Highway Officer: Robert Smith
Our ref: AVBC/2026/016978
Your ref: AVA/2026/0153
Date: 5 May 2026

TOWN AND COUNTRY PLANNING ACT 1990
(DEVELOPMENT MANAGEMENT PROCEDURE) (ENGLAND) ORDER 2015
ARTICLE 18 CONSULTATION WITH HIGHWAY AUTHORITY

PROPOSAL: Reorganisation of existing waste transfer site to form vehicular parking facility. To include new perimeter security fencing and retaining structure, security lighting and new entrance from Public Highway.

LOCATION: Leedale Ltd Unit 43 Lydford Road Alfreton Derbyshire DE55 7RQ

Publicly maintainable highway shown in green

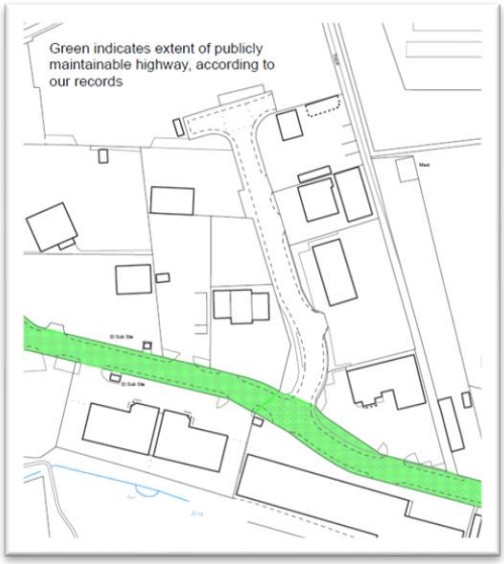
The site is located at the northern end of Lydford Road, an unadopted cul-de-sac forming part of the Meadow Lane Industrial Estate (see extract from highway boundary record below).

The site location plan does not confirm that the applicant has control of the unadopted section of Lydford Road which would provide access between the site and the public highway. The 'red outline' boundary shown on the site location plan should be amended accordingly.
